# Historical Affairs and Landmark Review Board

## HALRB Meeting June 21, 2023, CoA23-10

**1720 Queens Lane #168:** A request to install replacement vinyl windows which do not meet the *2015 Colonial Village Window Replacement ACoA Guidelines*.

Window Specifications

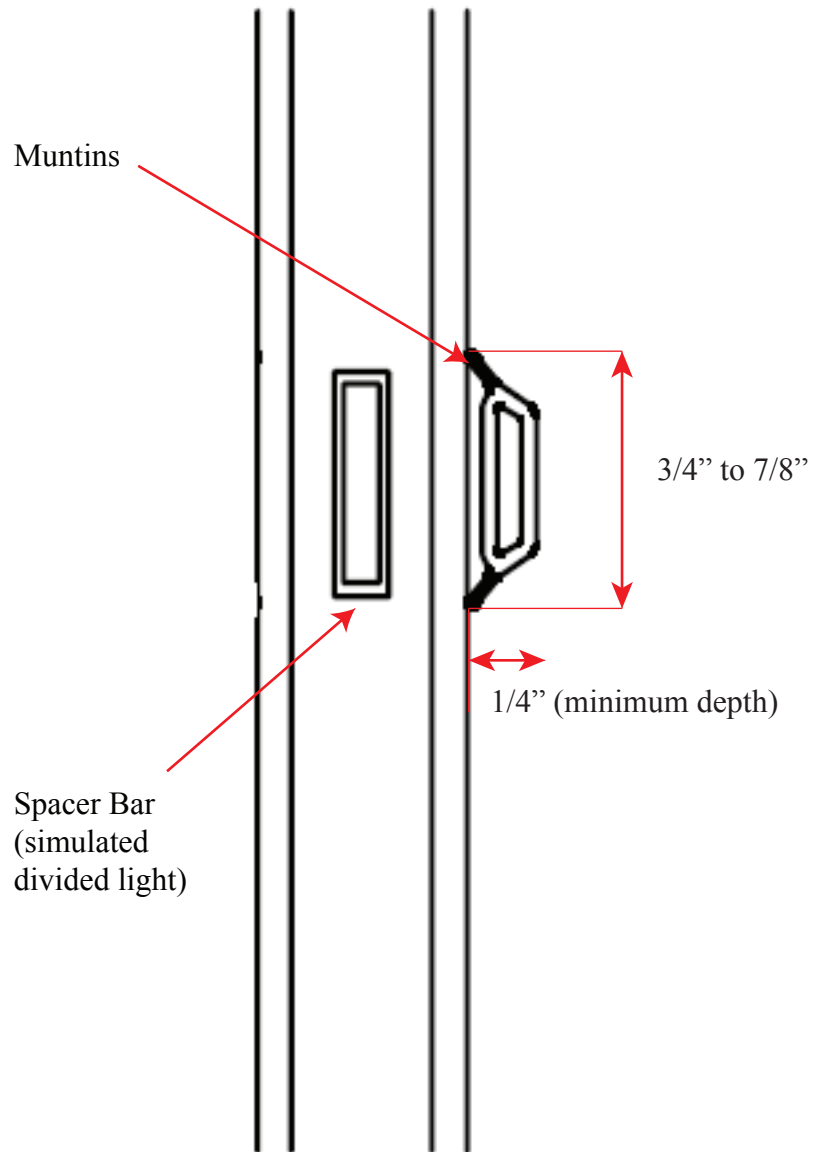
2 1/4"

6.5"

3/4"

3"

5/8"
